ALERT SERVICE BULLETIN
Bell Helicopter **TEXTRON**

NO. 222-07-104

MODEL AFFECTED: Model 222 and 222B

SUBJECT: TAIL ROTOR PITCH CHANGE MECHANISM,
REVISED RIGGING PROCEDURES

Figure 1. Tail Rotor Pitch Change Mechanism (Position)

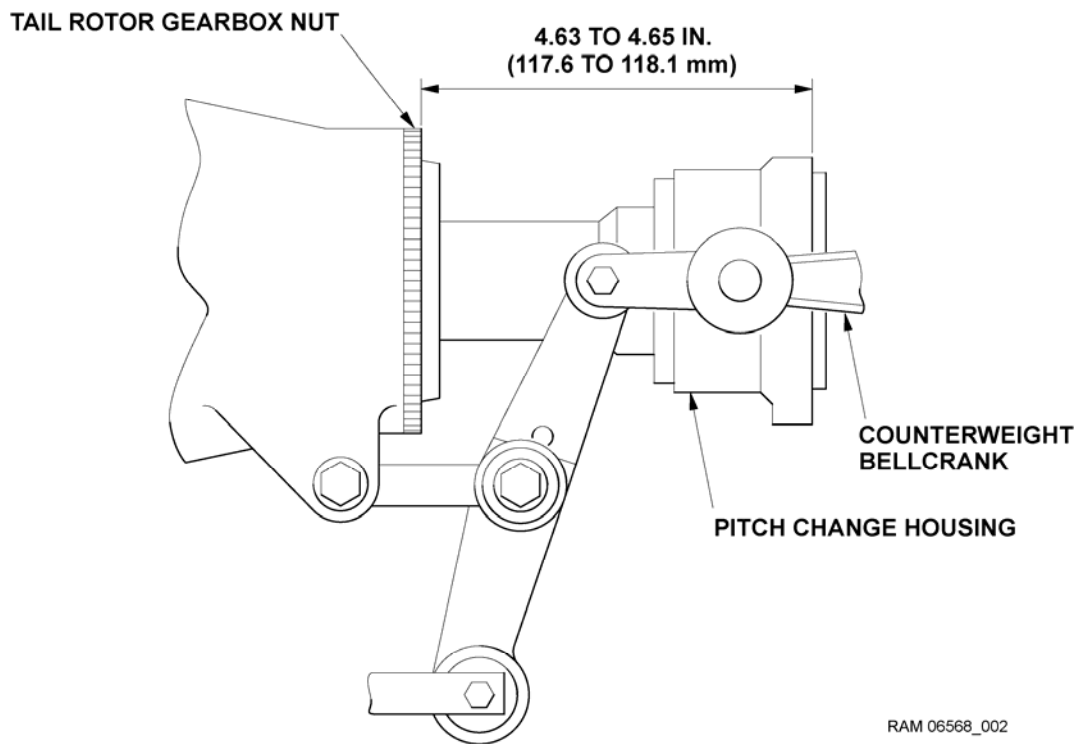
1. Move the tail rotor pedals as required and set the pitch change housing to obtain a 4.63 to 4.65 inches (117.6 to 118.1 mm) dimension as shown in Figure 1. Maintain this position.

There is no maximum limit on the gap that may exist between the tail rotor yoke and nut (4) when the pitch change housing is positioned as shown in figure 1 and the counterweight bellcranks (12) are parallel to the tail rotor gearbox output shaft.

Figure 2. Tail Rotor Pitch Change Mechanism

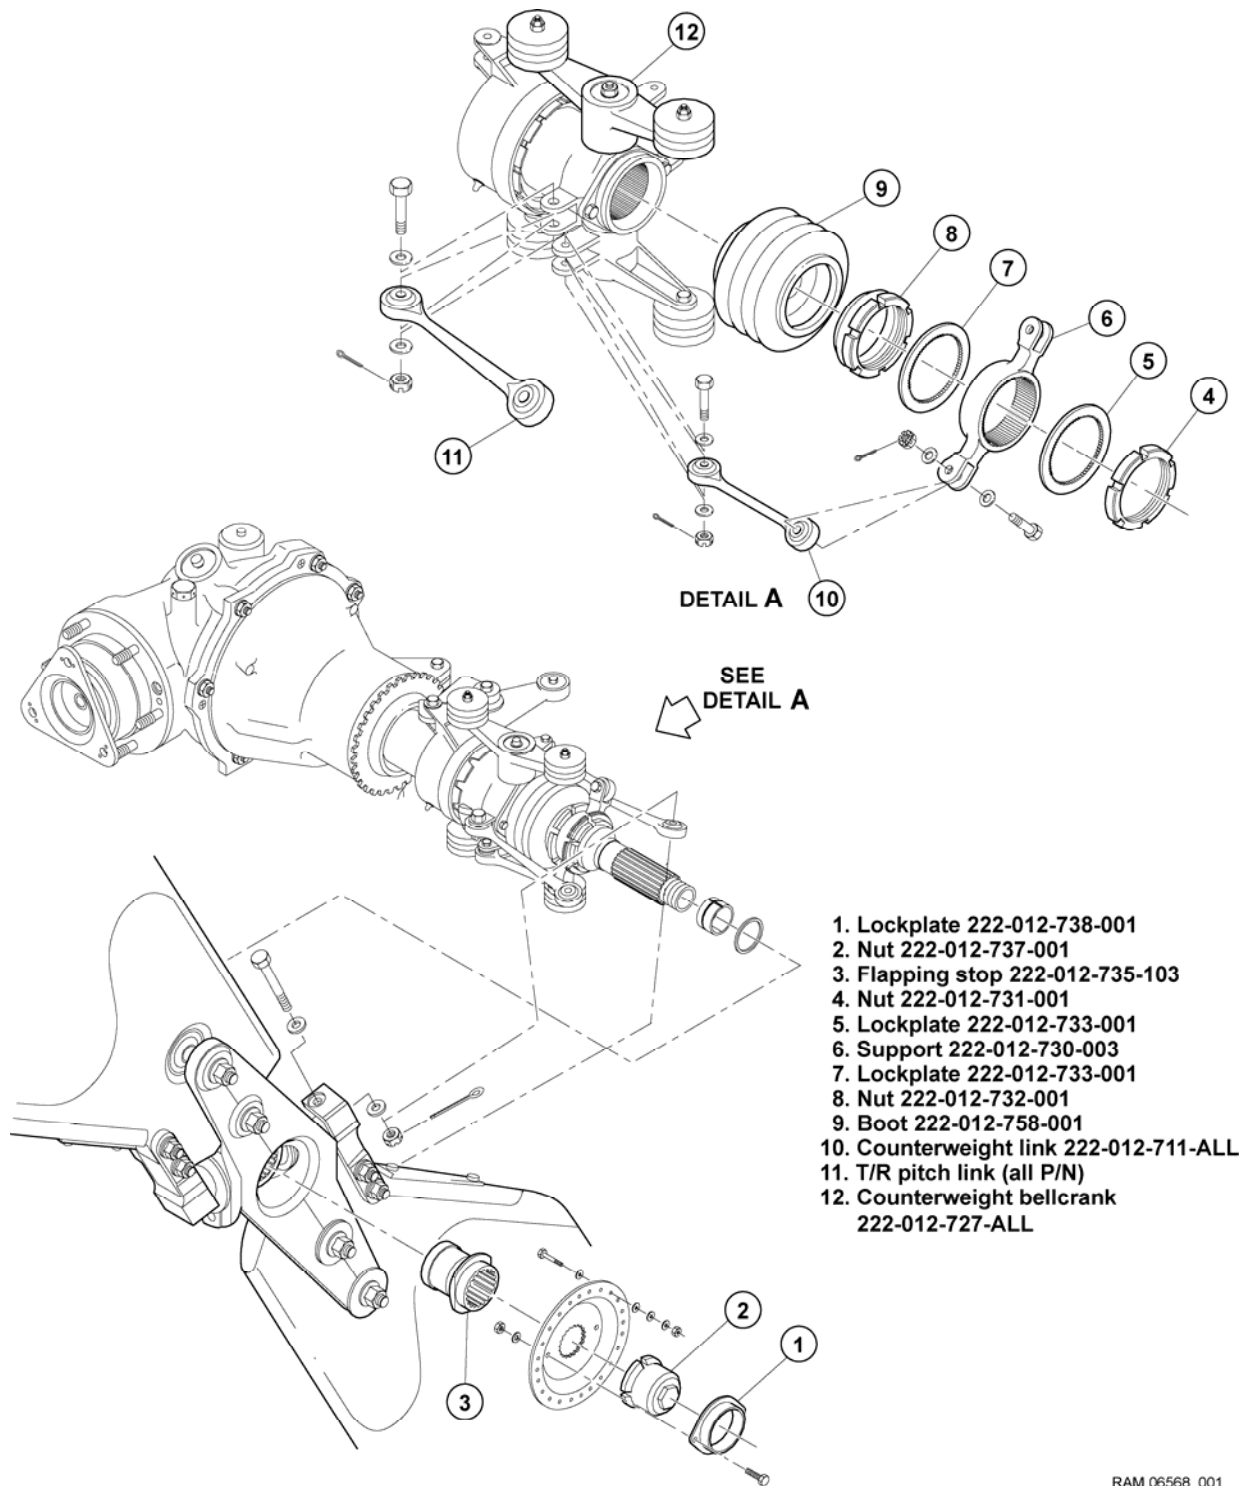
2. Verify that the centerline of counterweight bellcranks, (12, Figure 2) are parallel with the centerline of the tail rotor gearbox output shaft. If the counterweight bellcranks (12) are parallel with the centerline of the tail rotor gearbox output shaft, proceed to step 3. If the counterweight bellcranks (12) are not parallel with the centerline of the tail rotor gearbox output shaft, disconnect boot (9), pitch links (11) and counterweight links (10) as required. Straighten the bent edges of the lockplates (5 and 7) and adjust nut (4) and nut (8) to reposition support (6) until the counterweight bellcranks are parallel with the centerline of the tail rotor gearbox output shaft. Hold the nut (8) in position and torque the nut (4) to 50 to 55 foot-pounds (68 to 75 Nm). Do not bend the edge of the lockplates (5 and 7) into the slots of nut (4 and 8) at this time.

3. Move the tail rotor assembly through the full flap range (verify at both full flap positions). Verify if the tail rotor yoke touches the flapping stop (3) before it touches nut (4). If a gap exists between the tail rotor yoke and the flapping stop (3), replace

4. If there is no gap between the flapping stop (3) and the tail rotor yoke, verify if a 0.020 inch (0.50 mm) wire type feeler gauge can be inserted between the tail rotor yoke and nut (4). If the smallest gap between the tail rotor yoke and nut (4) is 0.020 inch (0.50 mm) or more, bend the edge of the lockplates (5 and 7) into the slots of nut (4 and 8). Connect boot (9), pitch links (11) and counterweight links (10) as required and proceed to step 6.

Adjusting nut (4) and nut (8) to obtain a 0.020 to 0.030 inch (0.50 to 0.76 mm) gap between the tail rotor yoke and nut (4) will result in a minor misalignment of the counterweight bellcranks (12) in relation to the tail rotor gearbox output shaft. A maximum misalignment of 1.6 degrees of the counterweight bellcranks (12) in relation to the tail rotor gearbox output shaft is acceptable when the pitch change housing is positioned as shown in figure 1.

Do not adjust nut (4) and nut (8) to obtain a gap of more than 0.030 inch (0.76 mm) between the tail rotor yoke and nut (4). This will result in misalignment of the counterweight bellcranks (12) beyond the permissible maximum limit of 1.6 degrees (in relation to the tail rotor gearbox output shaft) when the pitch change housing is positioned as shown in figure 1. This is NOT acceptable.

5. If the gap between the tail rotor yoke and nut (4) measures between 0.000 and 0.019 inch (0 to 0.48 mm), adjust nut (4) and nut (8) until a gap of 0.020 to 0.030 inch (0.50 to 0.76 mm) maximum exists between the tail rotor yoke and nut (4). Hold the nut (8) in position and torque the nut (4) to 50 to 55 foot-pounds (68 to 75 Nm). Bend the edge of the lockplates (5 and 7) into the slots of the nut (4) and nut (8). Connect boot (9), pitch links (11) and counterweight links (10) as required.
6. Examine and adjust the tail rotor pedal forces if any adjustments were carried out to support (6). Refer to BHT-222/222B-MM-1, chapter 65-30-00.
7. Annotate helicopter records to reflect compliance with this bulletin.
8. Insert the BHT-222/222B-MM-1 Revision 5, dated 15 Dec. 2007 into the BHT-222/222B-MM-1 manual.
